**ADDENDUM NO. 3
TO THE
BIDDING REQUIREMENTS AND CONTRACT DOCUMENTS
FOR THE
DIV IV DRY WEATHER PUMP STATION AND FORCE MAIN REHABILITAITON**

OWNER: **City of Anderson**

ISSUED BY/ENGINEER: Egis Group
8320 Craig Street
Indianapolis, Indiana 46250

ISSUE DATE: January 8, 2026

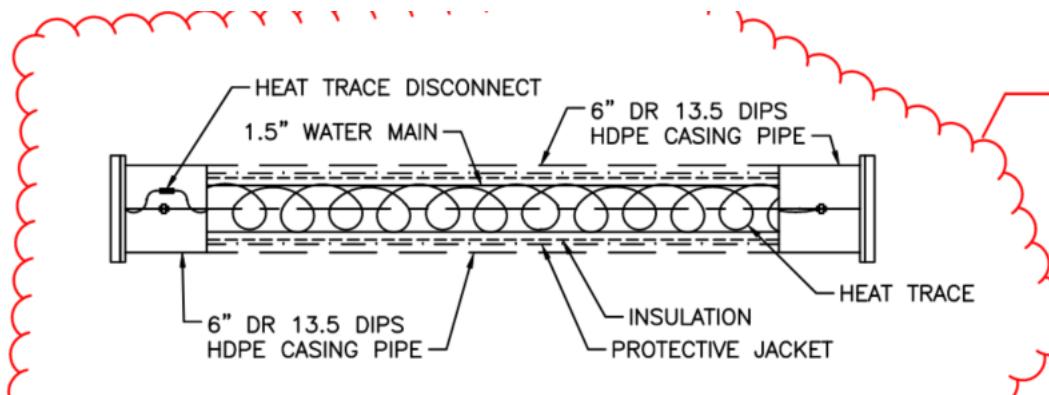
- C. Drawing E103, Keynote 1 indicates to remove breaker, while drawing E104, Keynote 1 indicates to reprogram breaker. Please clarify whether the intent is to reuse the existing breaker in SWB-1 and reprogram it, or to remove and replace the breaker.

Response: This item was clarified in Addendum #2. The breakers associated with 2A, 2B, and 6D on the one-line diagram and the front elevation are to be reprogrammed. The breakers may need to be removed to facilitate the required work in the space.

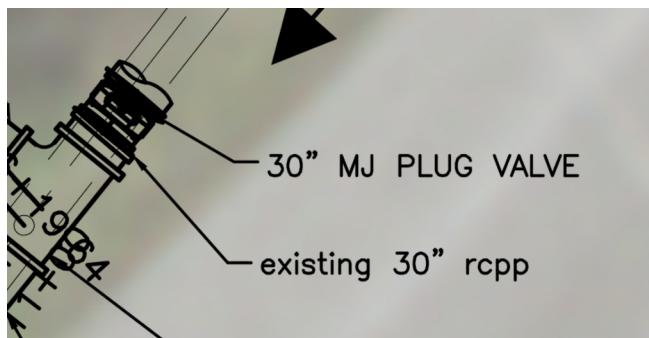
F. Can you clarify the intent of the below detail and where this is required? Is this the entire seal water line or just at valve vault penetrations. If this is used outside of structure, would a standard insulation jacket be acceptable? The leaders on each side of the section shown below are switched. On one side, the DI pipe leader points to the flanged section and on the other side the HDPE casing pipe points to flanged section.

Response: The Owner has requested all heat traced line to be enclosed in a casing pipe. The flanges shown in the detail are shown incorrectly. The intent was to use an easy to obtain, thin wall plastic (DIPS size HDPE) pipe for encasement. The intent was not to use any steel or ductile iron pipe for encasement. For PVC to be considered a protective UV coating would be required.

SHEET NO. C106

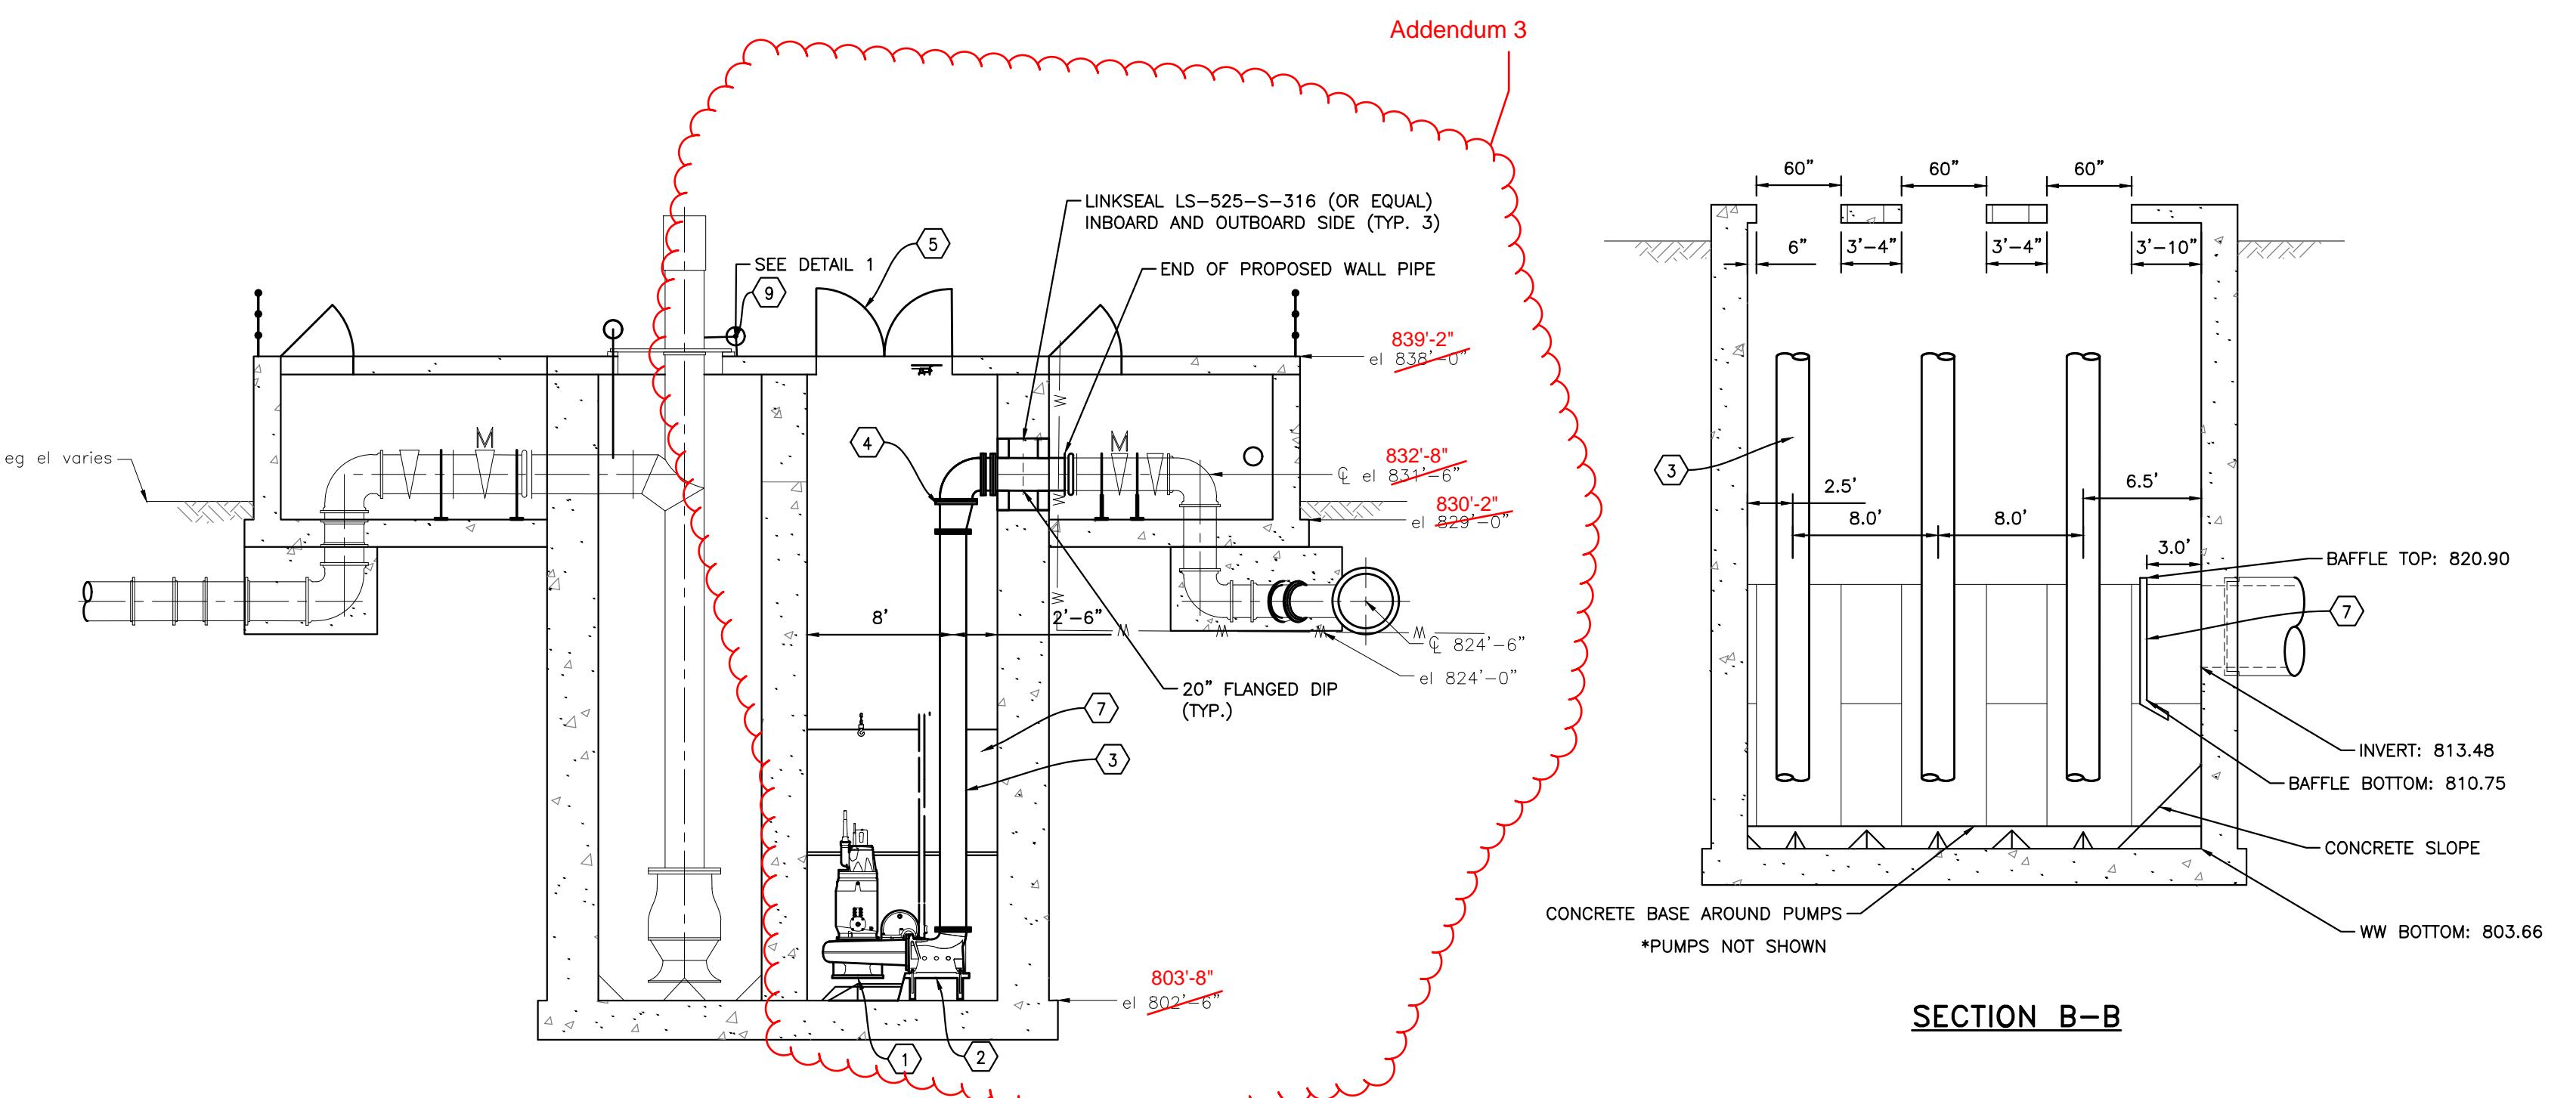
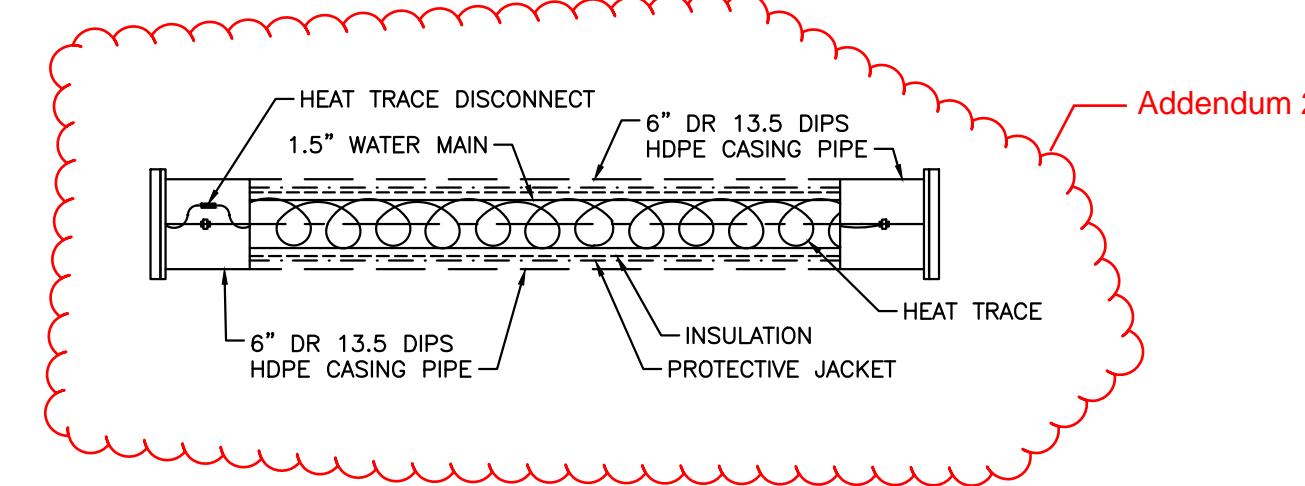
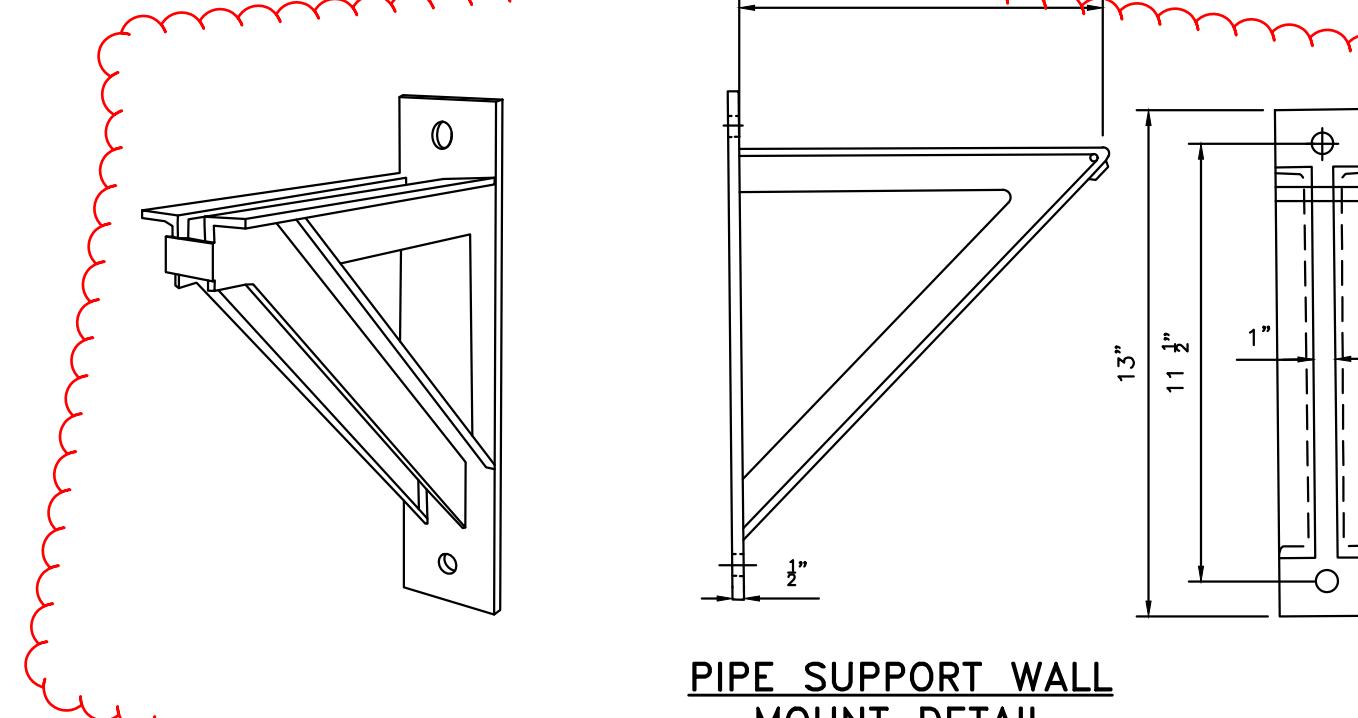
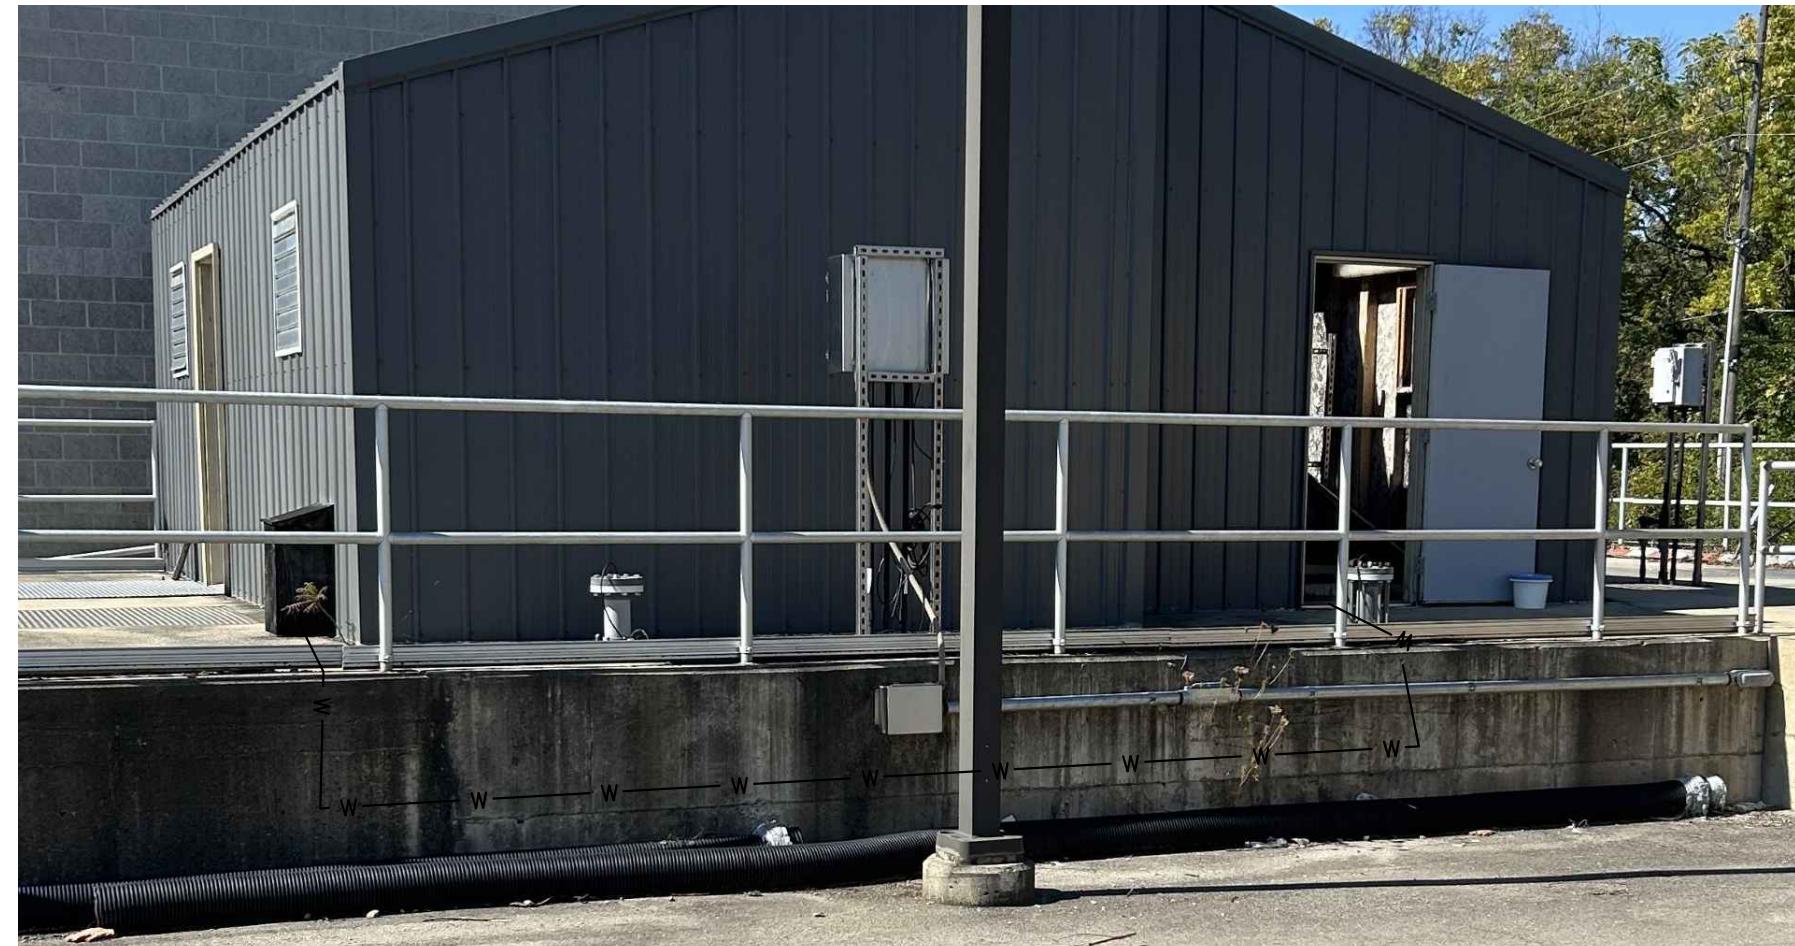
- A. Sheet C106 – Updated elevations have been added to Sheet C106.
- B. Sheet C107 – Updated elevations have been added to Sheet C107.
- C. Sheet C300 – Updated Trench Detail table.

E. Are dry-prime (vac-assisted) pumps an option? How deep below-grade is the water surface, and how deep overall is the wet-well? What is the minimum depth level allowed between grade and water surface?

Response: Specification Section 07721 only lists an acceptable manufacturer for roof scuttles/hatches under section 2.9.K. The following are acceptable manufacturers for all other hatches: Bilco, Halliday, EJ, and Flyght/Xylem. This information will also be added to Specification 07721 Section 2.5. All hatches must be able to meet the technical specifications and the physical opening requirements listed on drawing C107 Note 5.

Response: Diesel powered dry-prime pumps are acceptable for bypass pumping. Wet well top and bottom elevations are provided on the plan sheet C107. Please refer to the attached 2009 plan sheets of the screen structure for depth information, including maximum water surface information during wet weather. Bidders are encouraged to visit the site as well if unable to attend the advertised pre-bid meeting. Site visits must be pre-arranged with Engineer.
